NOTICE OF DECISION
Stream Corridor Modification – 4821 E Portland Road – MISC222-0004

DECISION AND FINDINGS
Stream Corridor Modification – 4821 E Portland Road – MISC222-0004

REQUEST: Stream corridor modification related to a pump station at the Crestview Green Planned Unit Development

SHEET NUMBER
C000

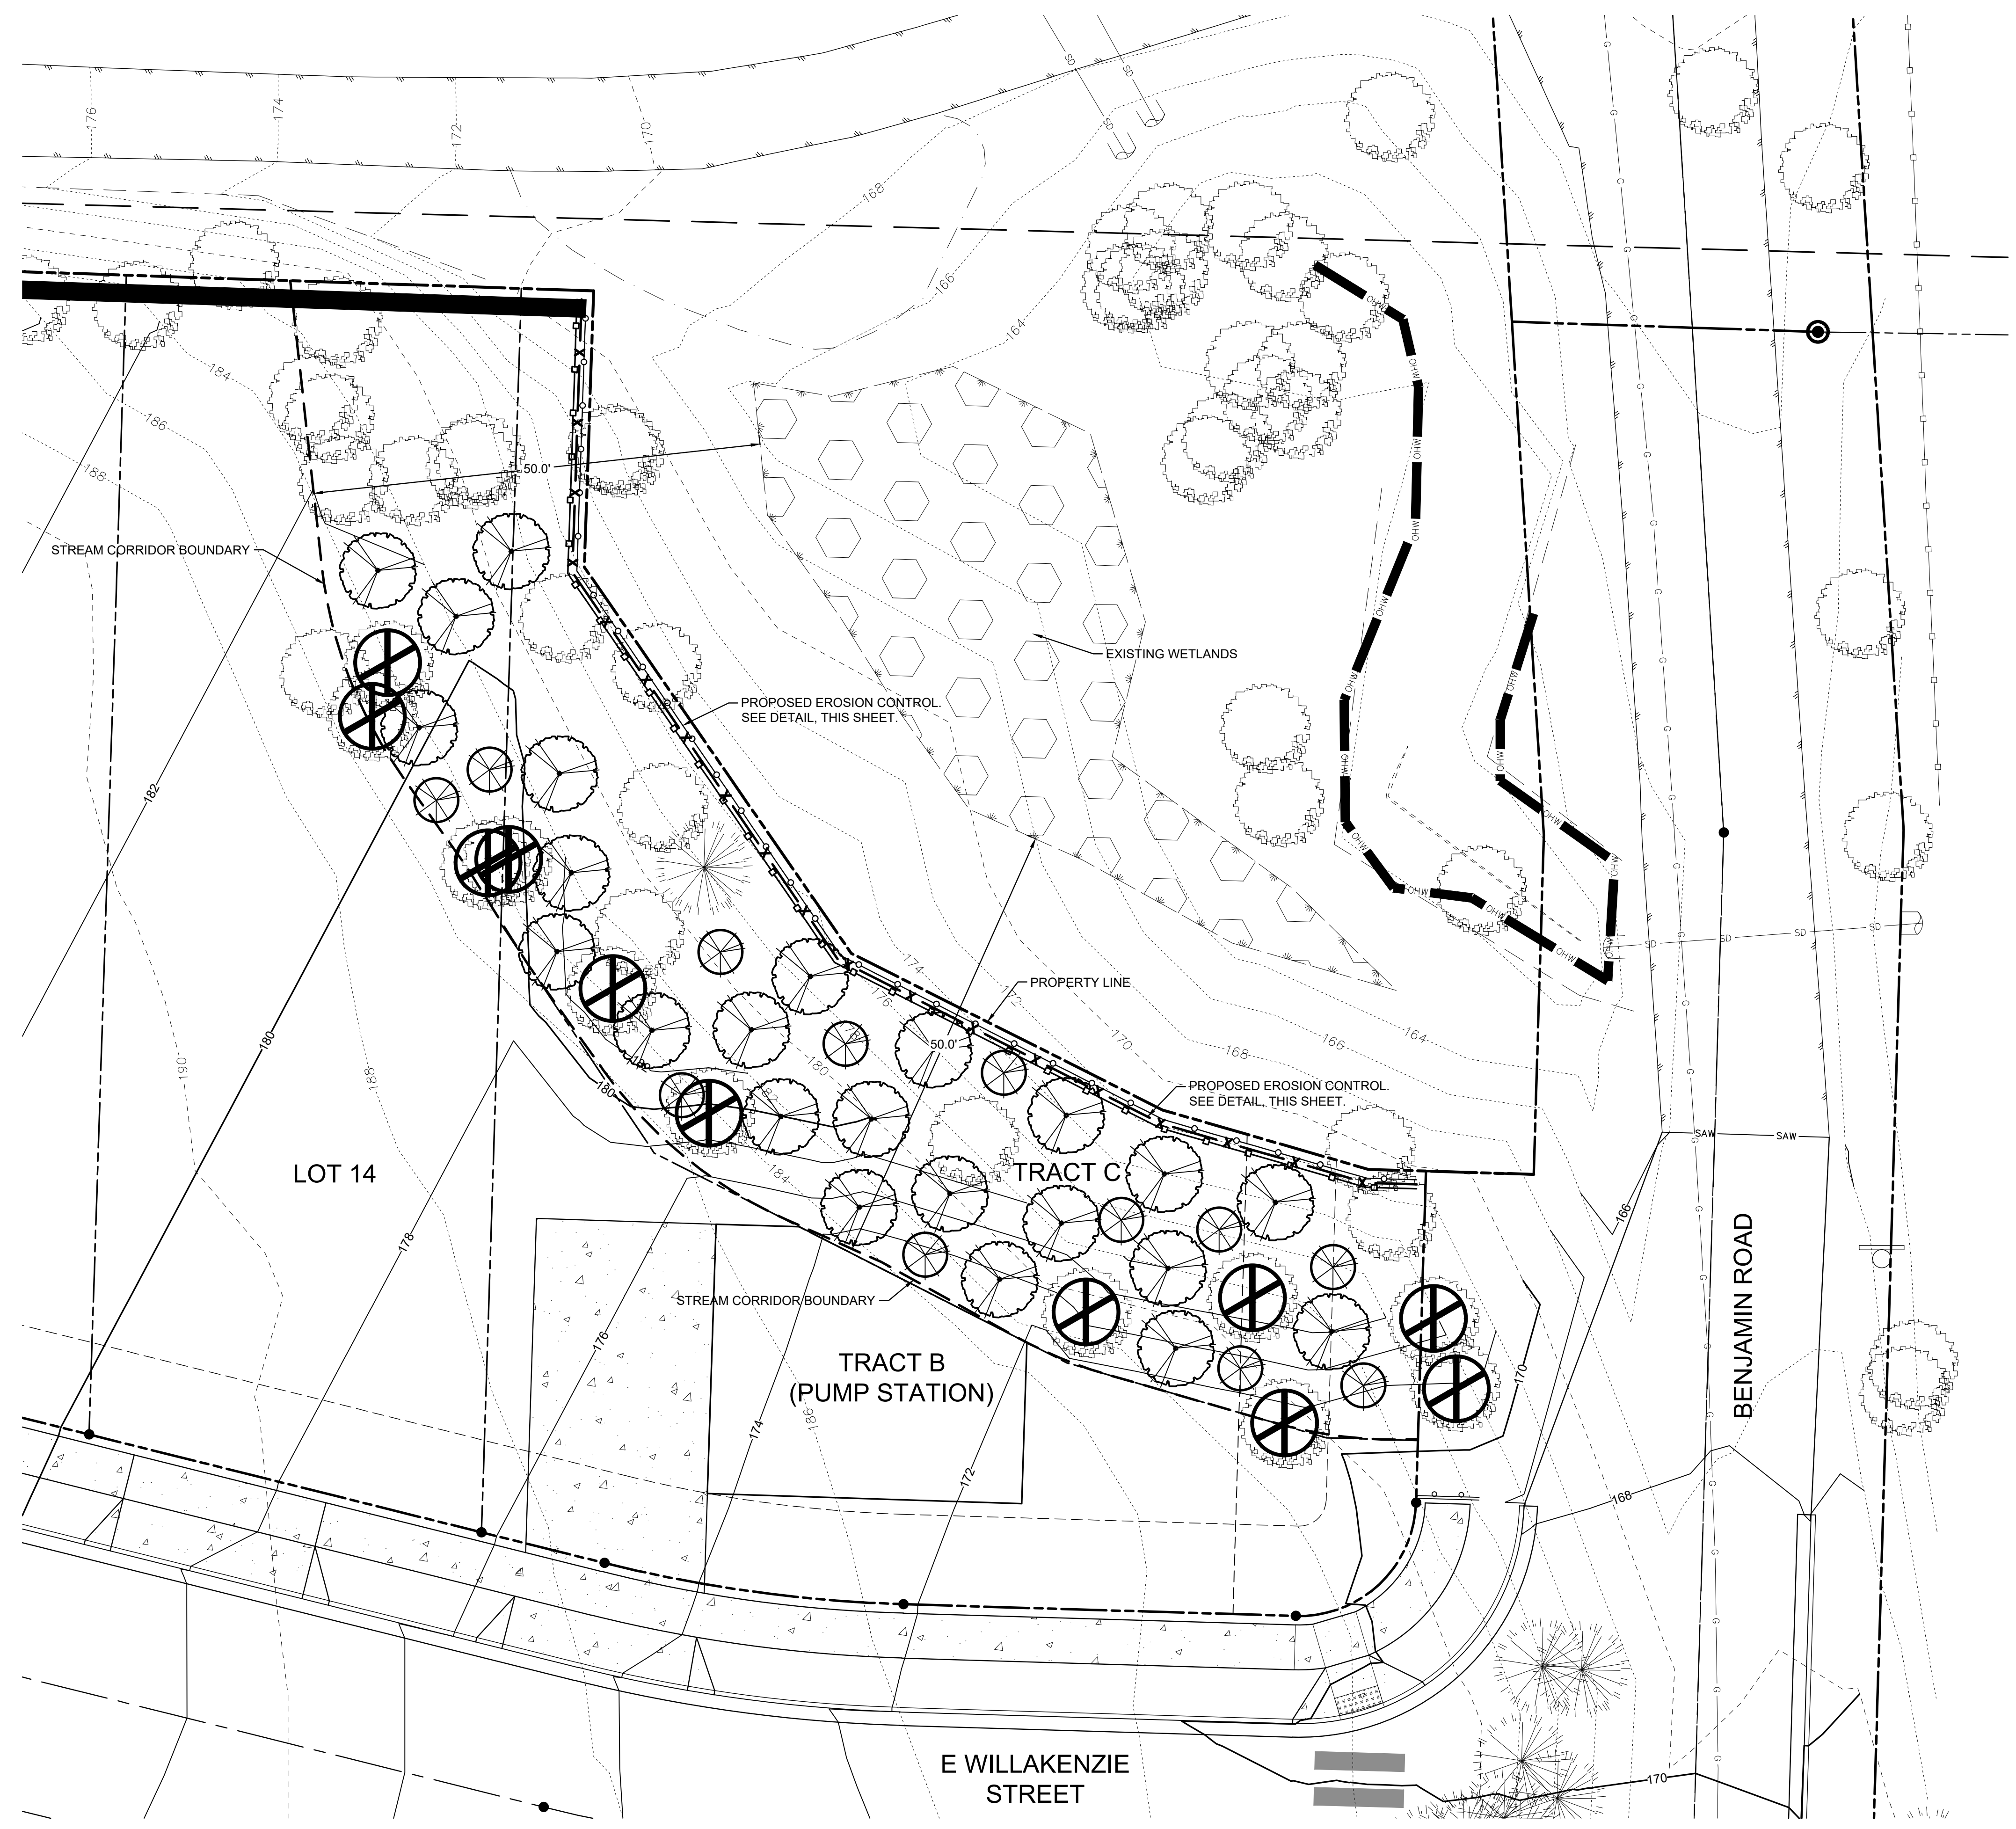
Finding: A site plan showing the item listed above is in Appendix “B” Land Use Plans, Sheets C000. Trees are identified as either deciduous or conifer and the size of each tree is identified.

Finding: A site plan showing the item listed above is in Appendix “B” Land Use Plans, Sheets C000 and C001. Existing contours and proposed contour modifications are identified. Contours are identified at 2-foot intervals.

SHEET NUMBER
C001

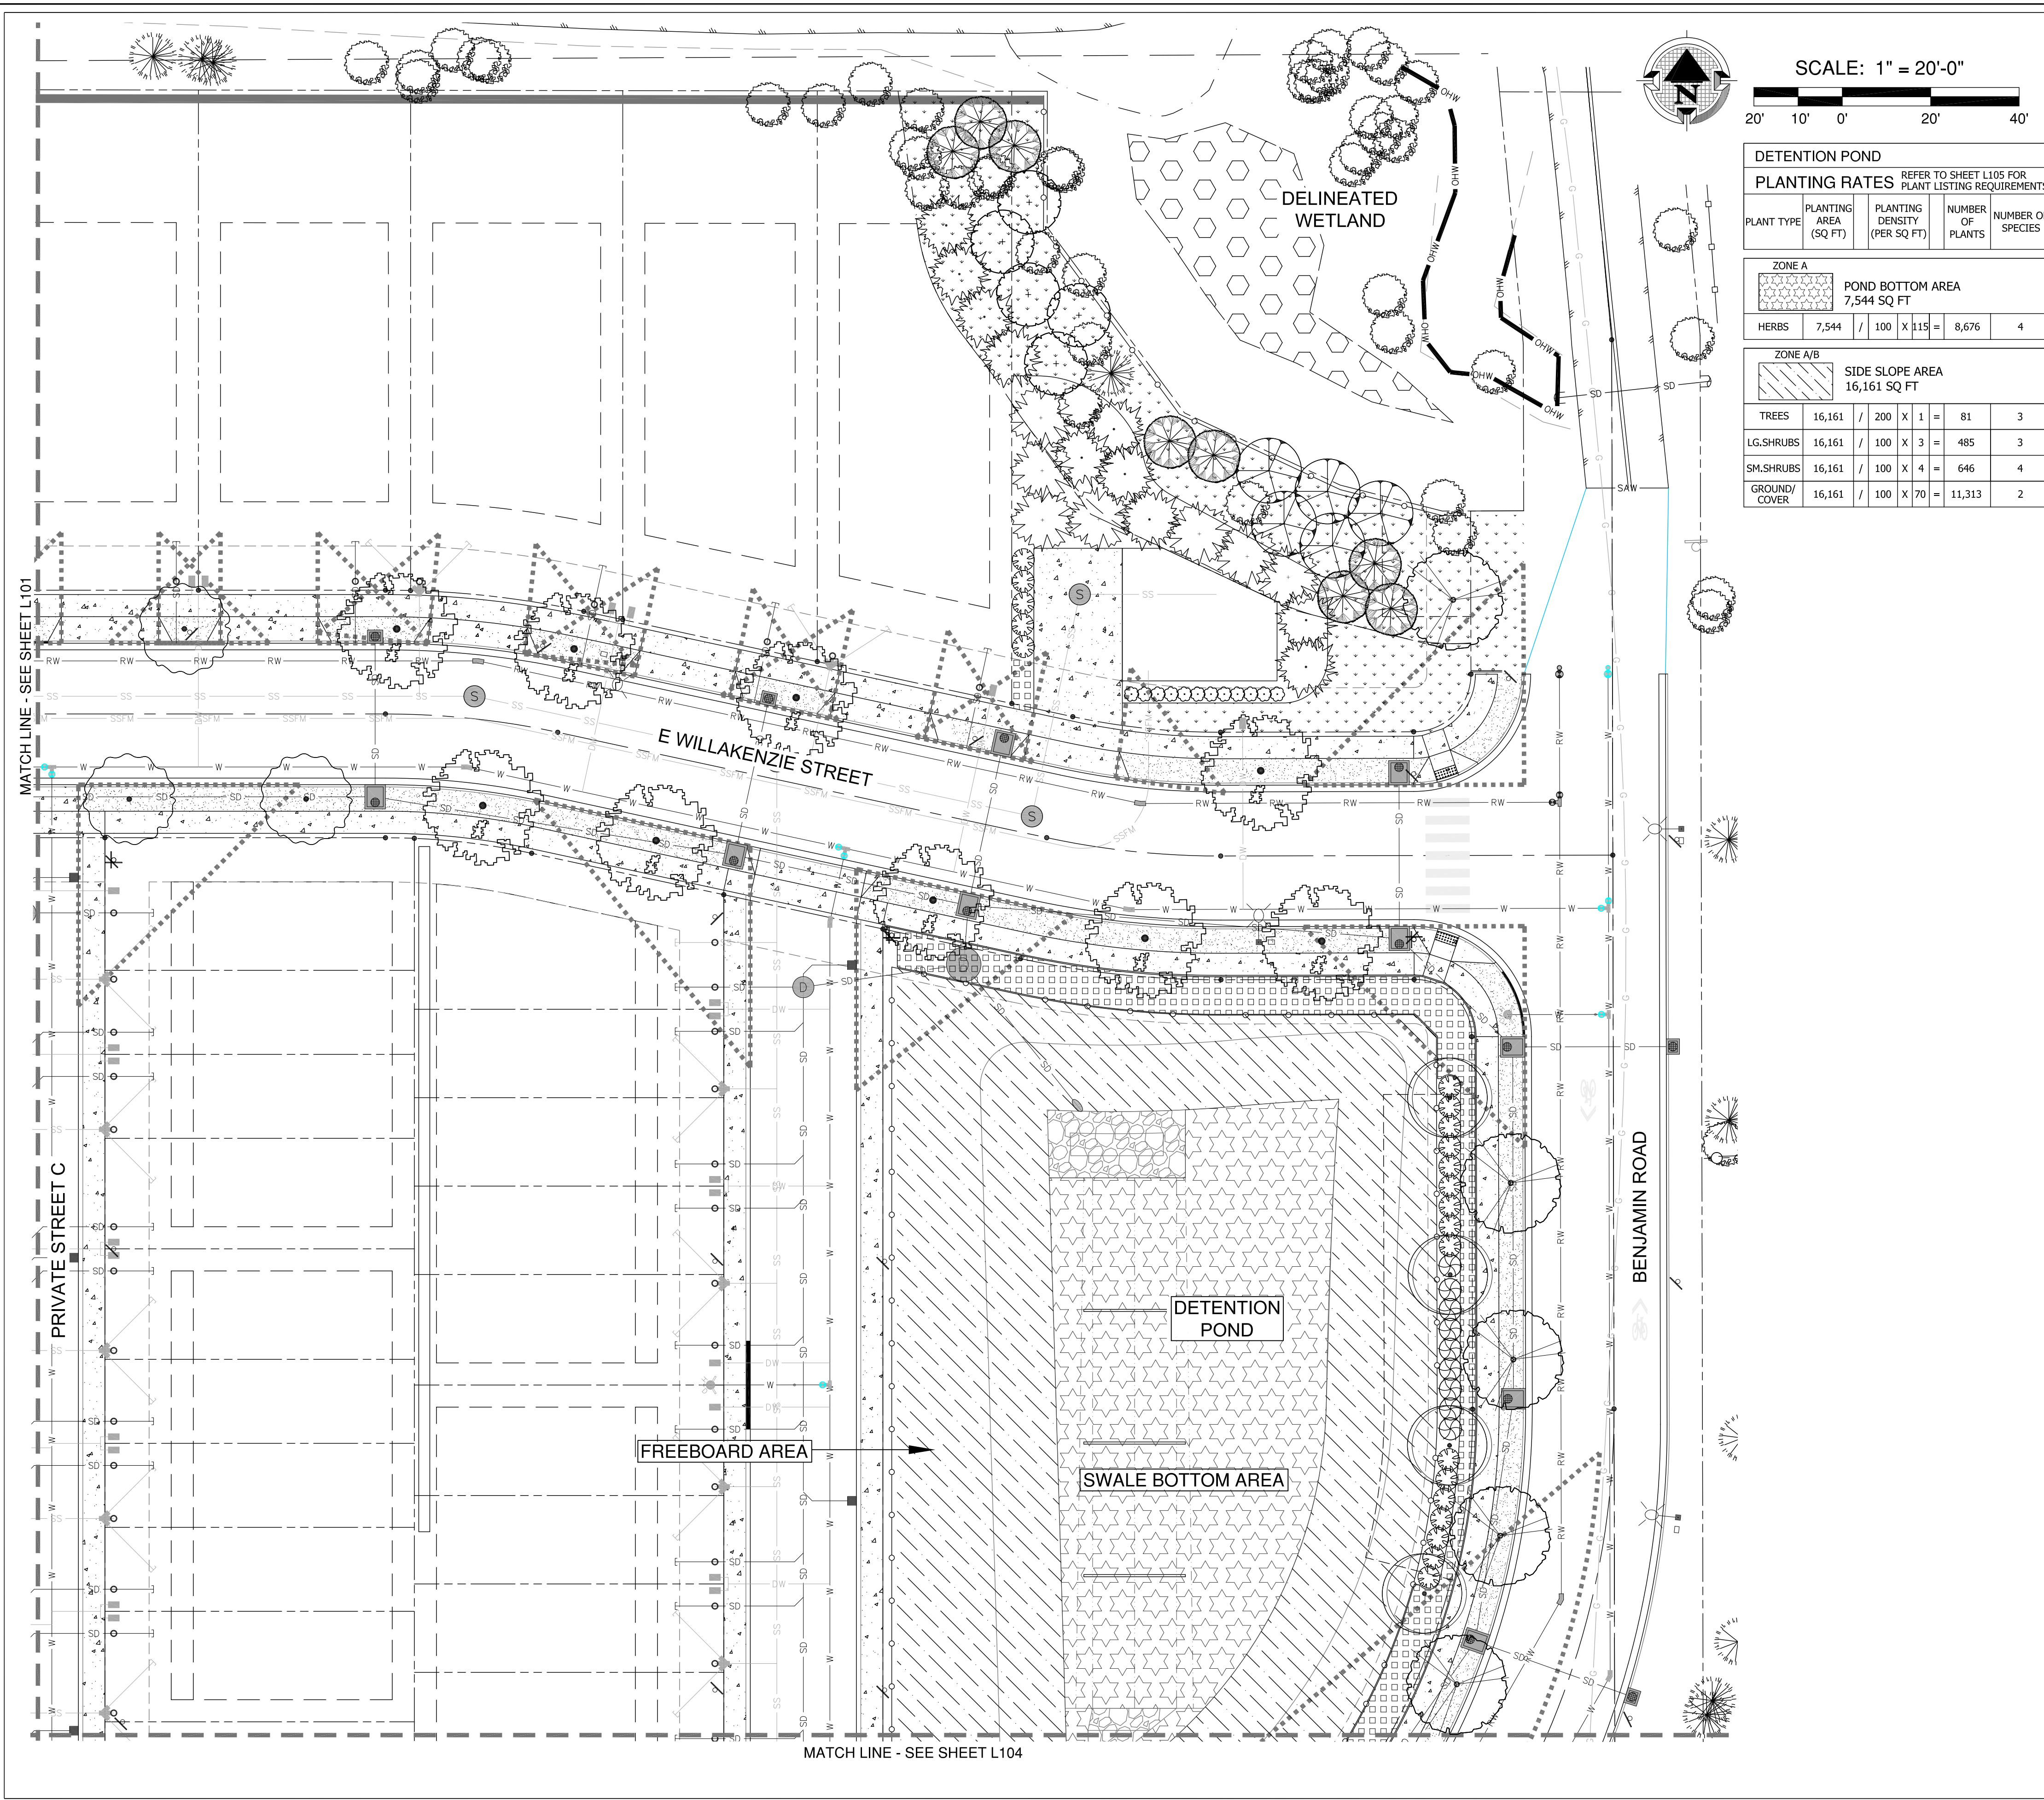
Appendix “B” Land Use Plans, Sheets C001 and L102 identifies a black line at the northern end of the identified Stream Corridor area. Conditions of approval for PUD22-0001, g.1. indicate:

No wall shall be placed within the Stream Corridor area. Sheet C001 also identifies a fence along the proposed property line of the Stream Corridor as part of the approved Property Line Adjustment. Placement of a fence at this location would impede the ecological value of the stream corridor for wildlife habitat. The Applicant shall revise Sheets C001 and L102 so that no sound wall encroaches within the Stream Corridor, and Sheet C001 shall be revised to not show a fence along the proposed property line as part of ADJP22-0002. A fence may be located at the top of the slope of the Stream Corridor boundary. The revised Sheet C001 and L102 shall be submitted to the Planning Division for review and approval prior to any grading activities and/or submittal of Building Permits.

Finding: The project boundary showing the disturbed area is shown in Appendix “B” – Land Use Plans, Sheet C001.

Finding: An Erosion Control Plan and associated narrative via sheet notes are shown in Appendix “B” – Land Use Plans, Sheet C001.

Finding: Appendix “B” - Land Use Plans, Sheet C001 identifies that 11 trees will be removed. Understory will also be removed within the grading area. All remaining trees will be preserved identified on Sheets C000, C001 and L102. As noted and conditioned groundcover will augment the understory of the mitigation area.

Finding: The application materials identify in Appendix “B” Land Use Plans, Sheet C001 that trees will be removed and replanted. There are 10 trees that are between 6 and 18-inches in diameter and will be replaced with 30 trees. One tree to be removed is over 18-inches in diameter and will be replaced by 5 trees. All replacement trees will be 1.5-inch in caliper.

Finding: The application materials identify in Appendix “B” - Land Use Plans, Sheet C001 that plantings are spaced to achieve 90% coverage in one year. The Applicant also notes that they understand a bond or other form of security may be authorized by the director to ensure completion of the restoration plan. The proposed tree, shrub and seed mix as conditioned will allow for achievement of 90% coverage in 1 year.

Finding: The application materials identify in Appendix “B” - Land Use Plans, Sheet C001 that erosion control devices will be utilized. The devices will be installed prior to construction and remain in place until 90% coverage is achieved.

1. The Applicant shall revise Sheets C001 and L102 so that no sound wall encroaches within the Stream Corridor, and Sheet C001 shall be revised to not show a fence along the proposed property line as part of ADJP22-0002. A fence may be located at the top of the slope of the Stream Corridor boundary. The revised Sheet C001 and L102 shall be submitted to the Planning Division for review and approval prior to any grading activities and/or submittal of Building Permits.
